**To** John Rosebrock - Rupp-Rosebrock, Inc.  
**Fax No.** (419) 533-8704  
**From** Adam C. Hoff, P.E. - City Engineer *ACH*  
**Date** 9/17/99  
**Subject** Rodenberger Funeral Home - Plan Review  
**Pages** 1, including this one

**DRAINAGE SYSTEM DESIGN  
FOR  
RODENBERGER FUNERAL HOME**

**Subject** Funeral Home Plan Review

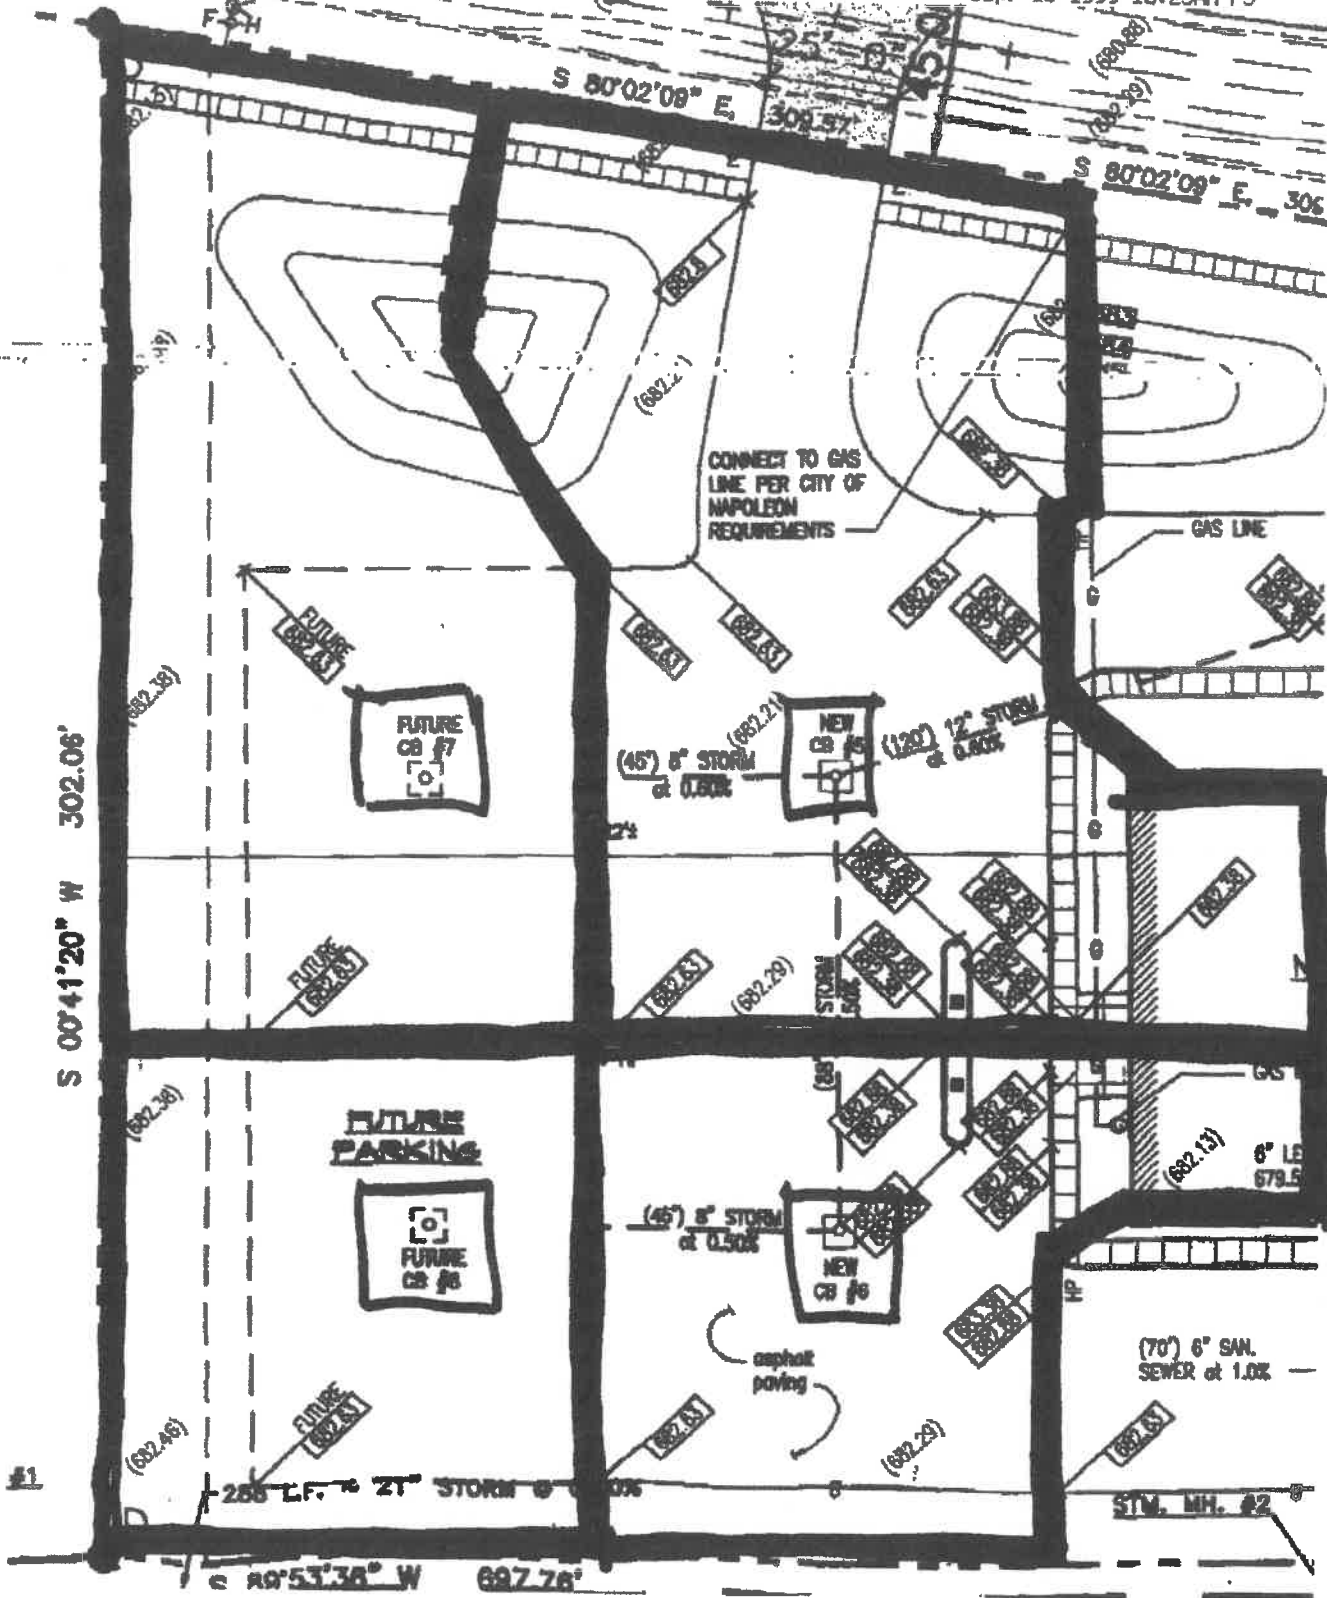
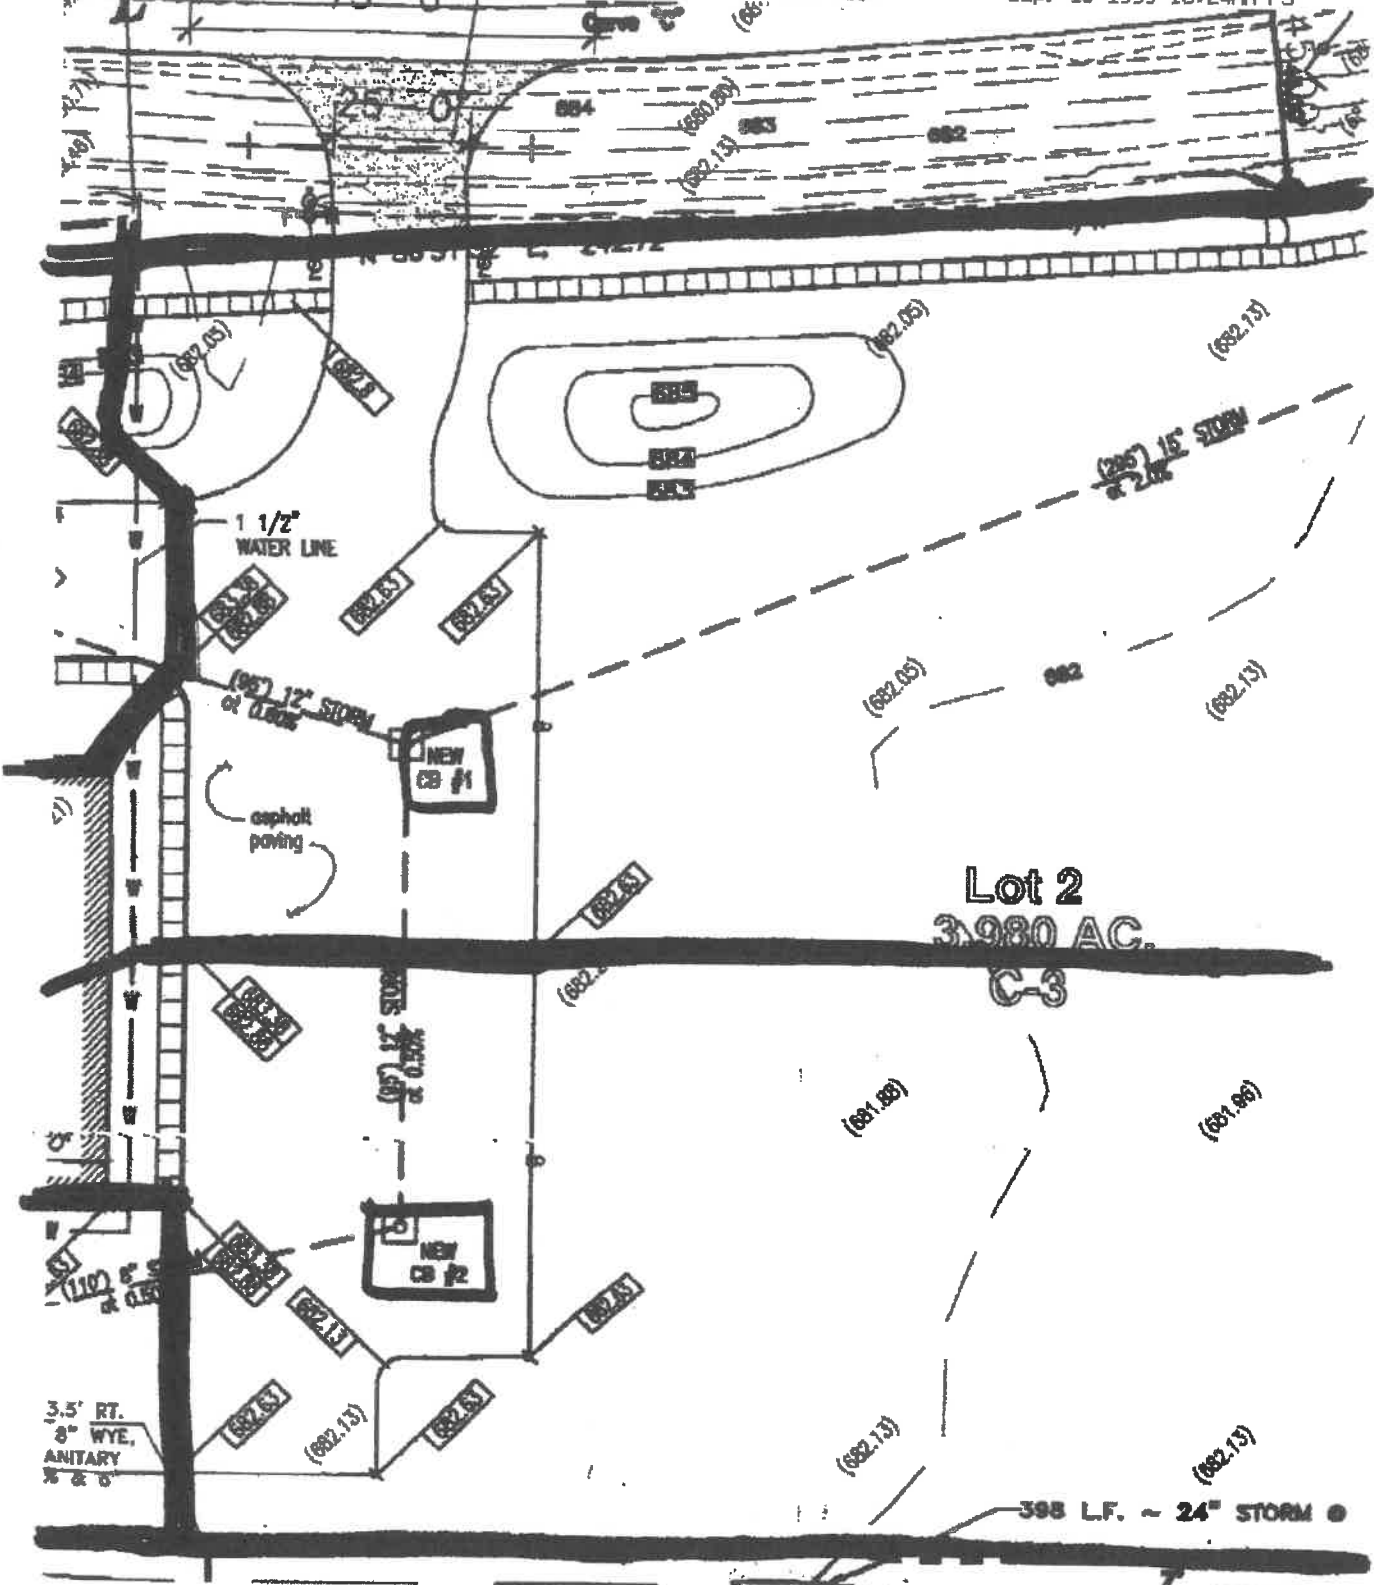
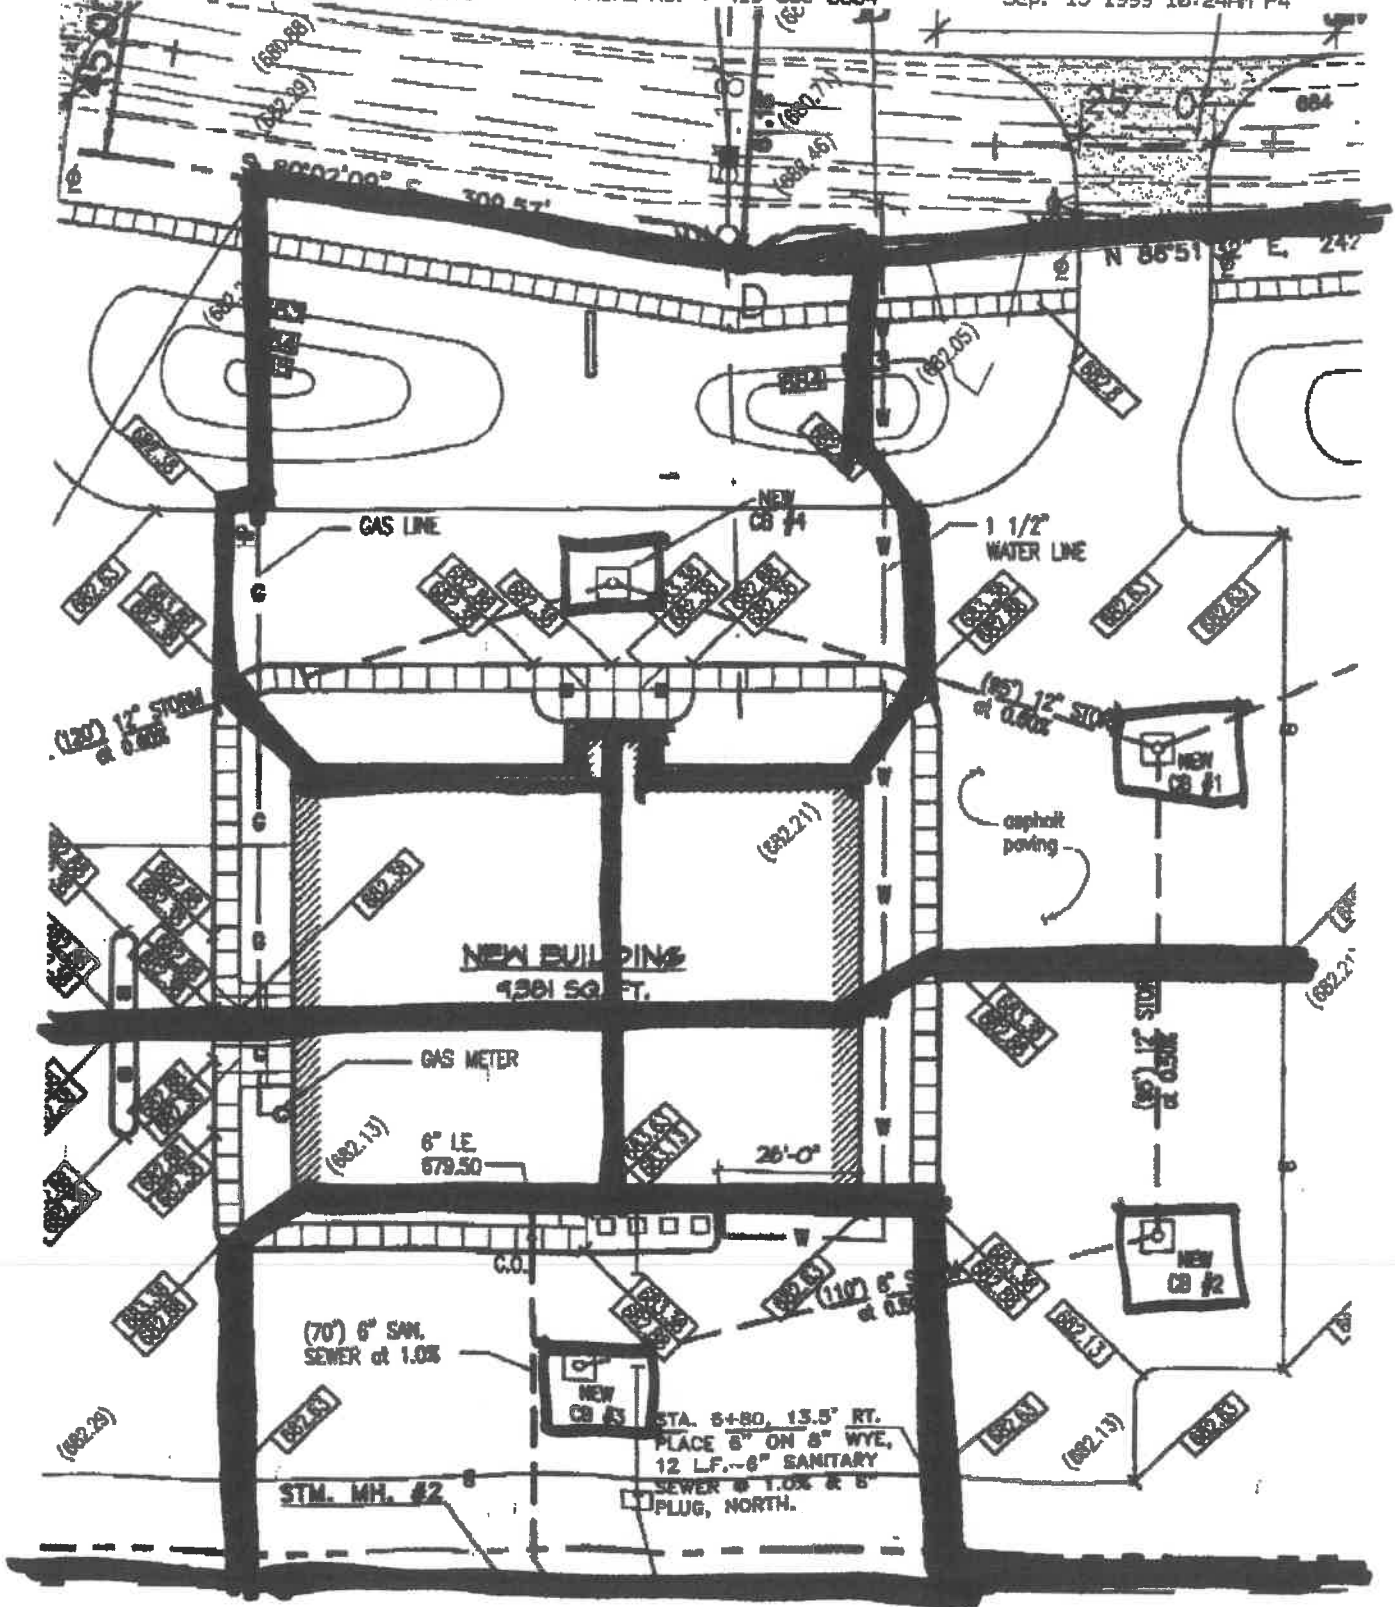
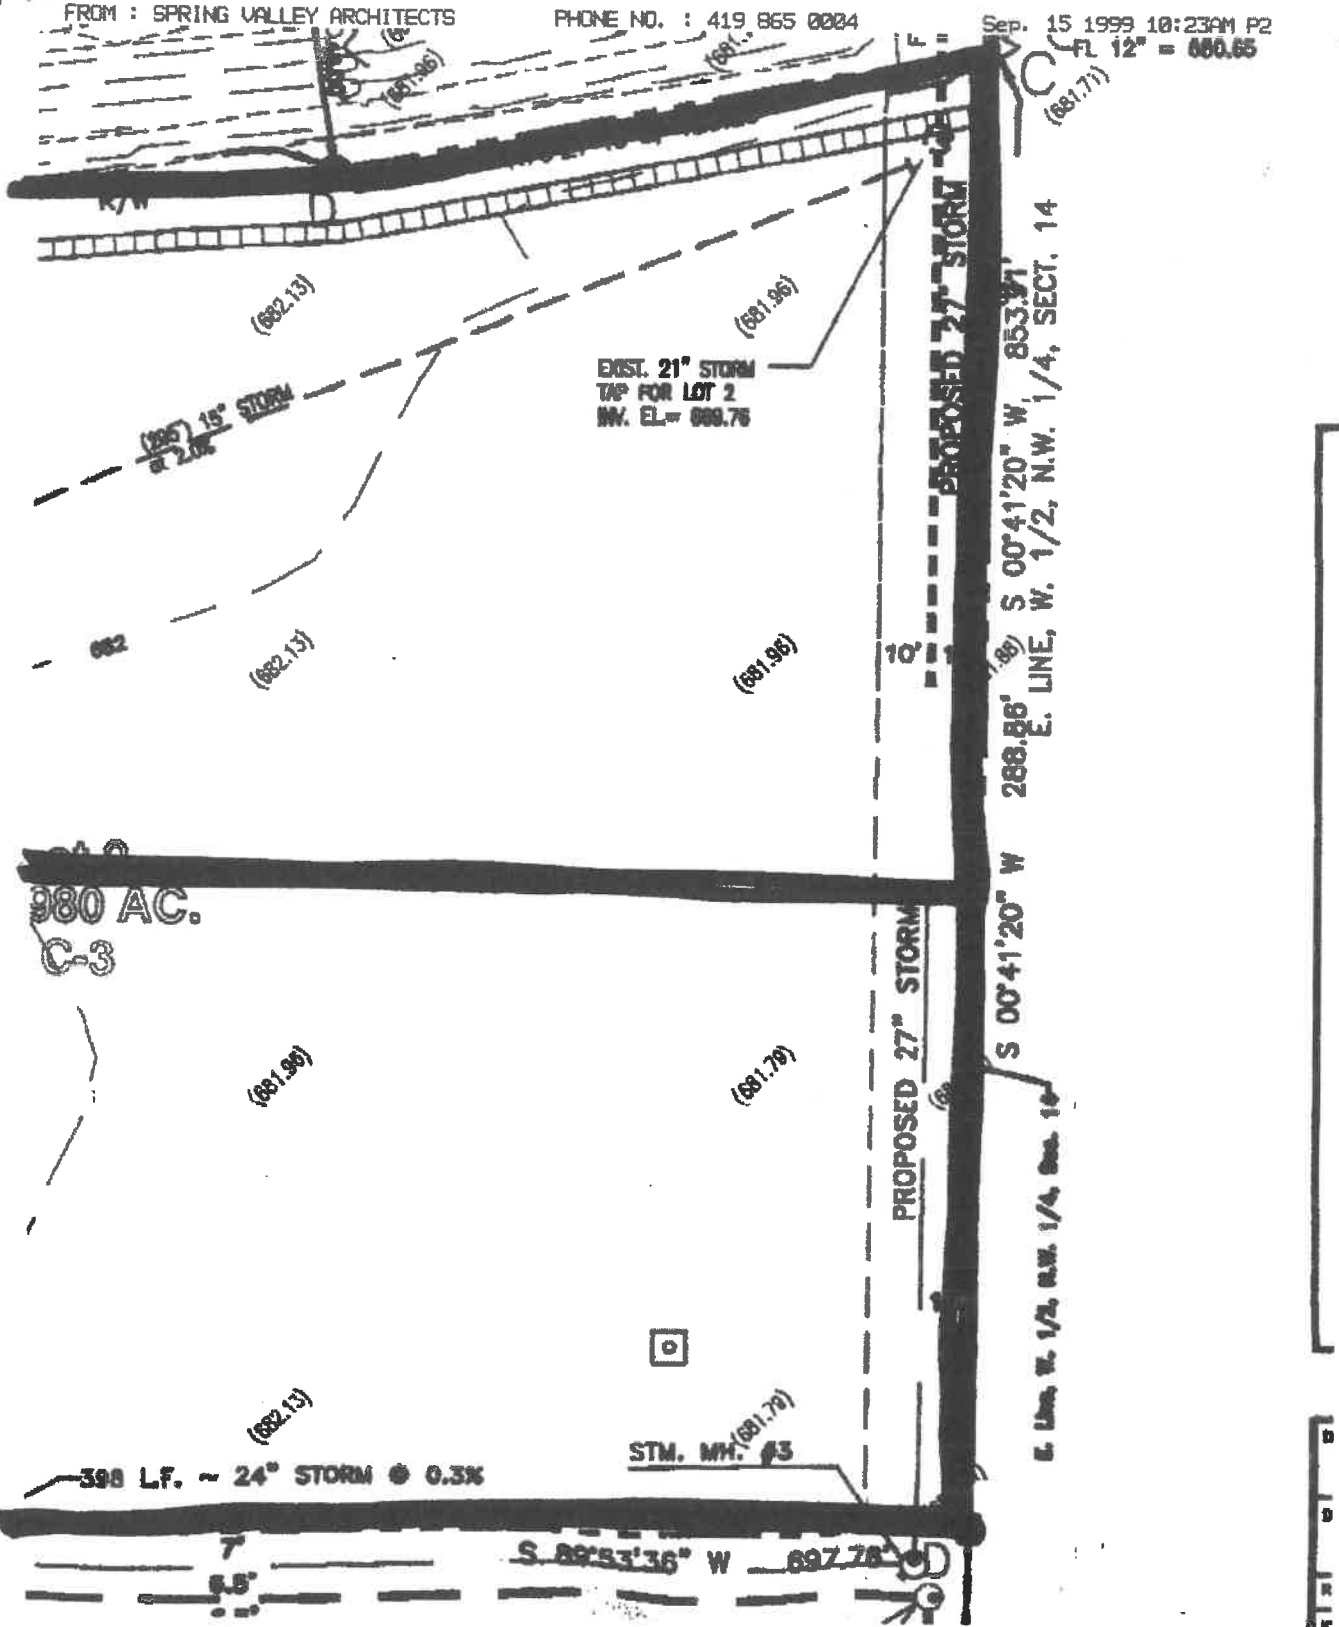
ATTACHED ARE OUTLINED DRAINAGE AREAS FOR YOUR USE IN EVALUATING  
RODENBERGER DRAINAGE PLAN. SORRY THAT I COULD NOT GET THIS TO YOU  
YESTERDAY. PLEASE CALL ME IF YOU HAVE ANY QUESTIONS.
